Subject: BODY VIBRATION AT CRUISE SPEED	Bulletin No: 03-001/06
	Last Issued: 7/21/2006

BULLETIN NOTE

This bulletin supersedes the previous bulletin issued on 7/12/2006. The REPAIR PROCEDURE section has been revised.

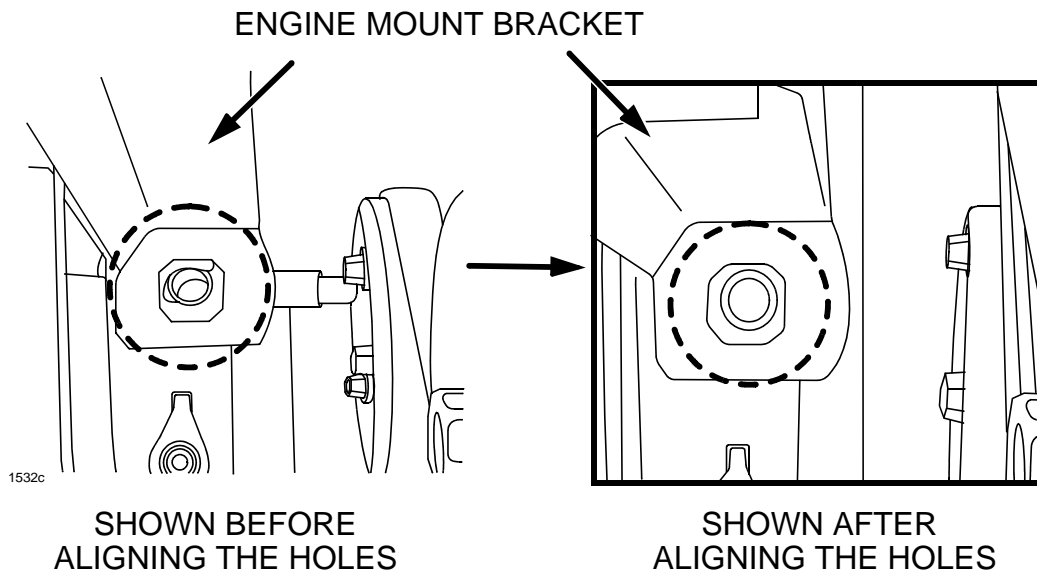
7. Lift engine using jack until No.3 engine mount is lifted slightly from vehicle body.

- Do not raise engine too much or A/C pipe damage may occur.

8. Move the engine mount rubber or engine until installation hole on the vehicle body aligns with hole in the engine mount bracket.

9. Lower the jack and tighten bolts on No. 3 engine mount bracket.

Tightening torque: 55.0-77.3 ft-lbf (74.5-04.9 N.m)

- Do not allow the engine mount bracket to be misaligned.

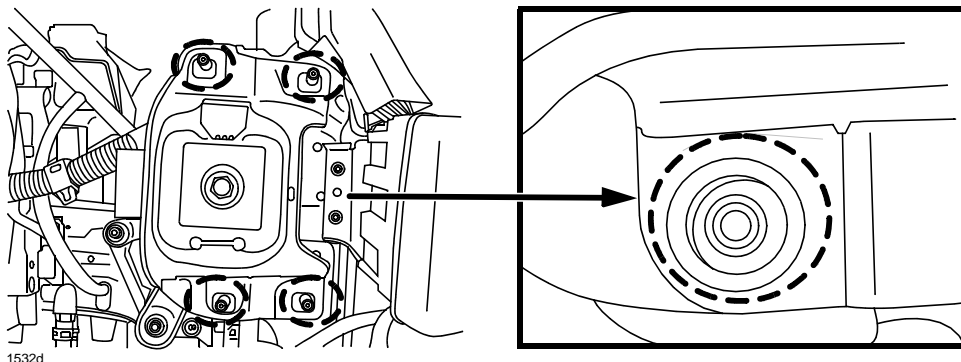
10. With engine supported as described in STEP 5, remove four (4) nuts and two (2) bolts from No. 4 engine mount top plate. Remove top plate.

- To access the mount, remove battery box.

TIGHTEN BOLTS IN SEQUENCE SHOWN

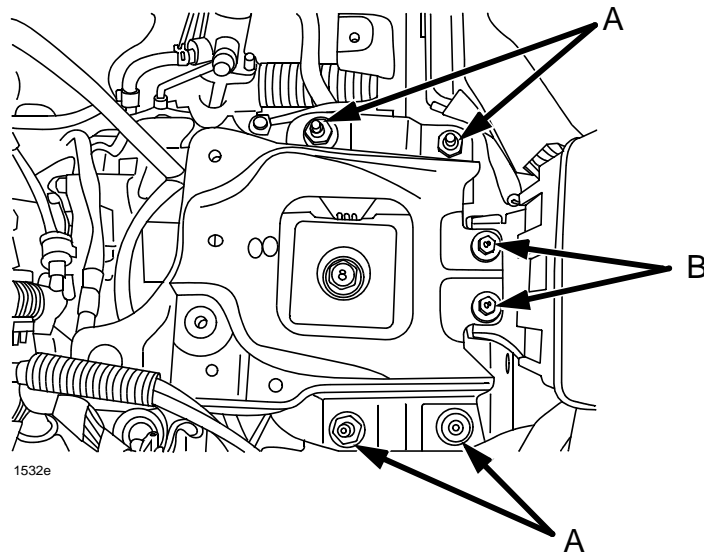
12. With top plate of No. 4 engine mount removed, move engine mount bottom plate or engine until all four (4) installation studs on the vehicle align with the engine mount holes.

ALIGN THE 4 STUDS IN THE PLATE HOLES

13. Place top plate back on and tighten No. 4 engine mount bracket nuts and bolts to torque indicated.
Tightening torque:
A. 32.5-45.0 ft-lbf (44.0-61.0 N.m)
B. 61.1-86.7 in-lbf (6.9-9.8 N.m)

LOOSEN THESE 2 BOLTS

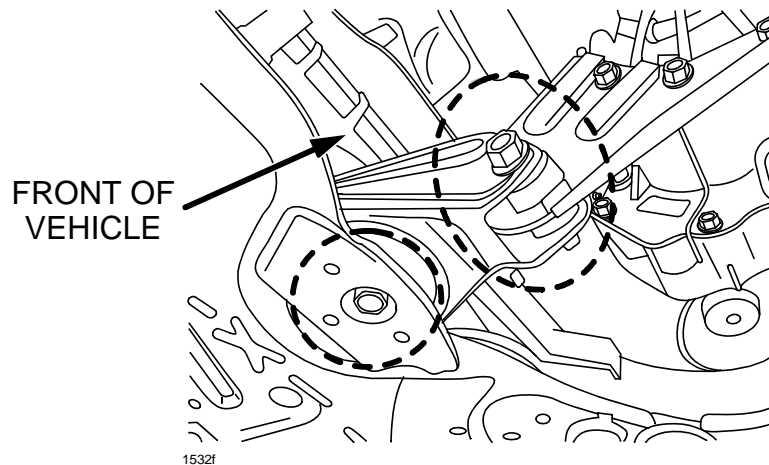
14. Lift engine again using jack and loosen the two bolts on the No. 1 engine mount rubber until slightly loose on the No. 1 engine mount rubber.

ROCK ENGINE BACK AND FORTH

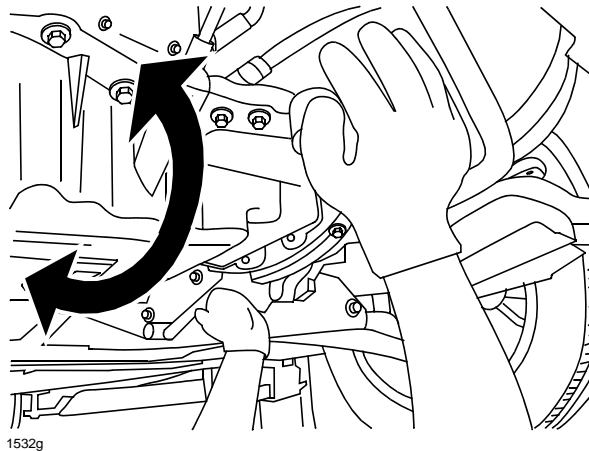
15. Shake/rock the engine back and forth.

TIGHTEN BOLTS IN SEQUENCE

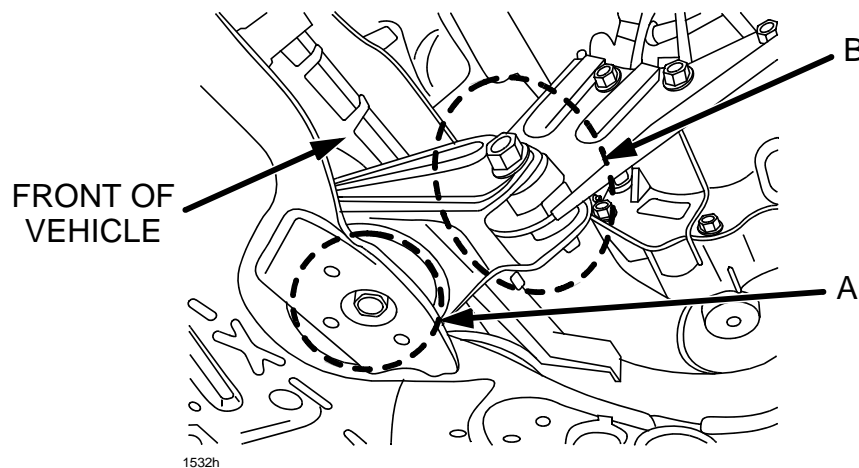
16. Tighten bolts in order below.

- A. Crossmember-side No. 1 engine mount rubber. Tightening Torque: 68.7-86.1ft-lbf (93.1-116.6 N.m)
- B. Engine-side No. 1 engine mount rubber. Tightening Torque: 68.7-86.1ft-lbf (93.1-116.6 N.m)

POSITION PIPES IN
CENTER OF BUSHING
(MAZDA5 SHOWN,
MAZDA3 SIMILAR)

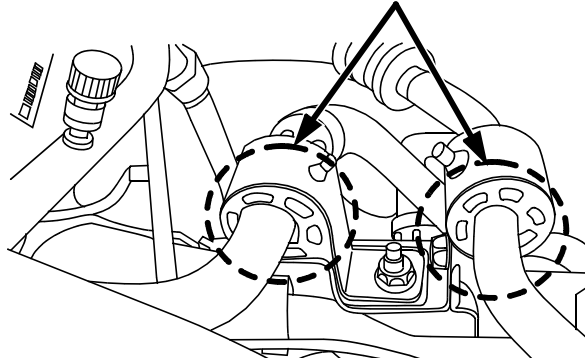
- A/C pipes and bracket are located on the right rear of the engine compartment, bolted to the frame rail.

1. Loosen the A/C pipe bracket bolt and/or nut.

2. Position the A/C pipe bracket so A/C pipes are as close to center in the bushings as possible.

- On Mazda5, center both A/C pipes, on Mazda3, center only the rear pipe as the front pipe cannot be centered due to bushing thickness.

3. Tighten the bolt and nut.

Tightening torque: 61.0-86.8 in-lb (6.89-9.80 N.m)
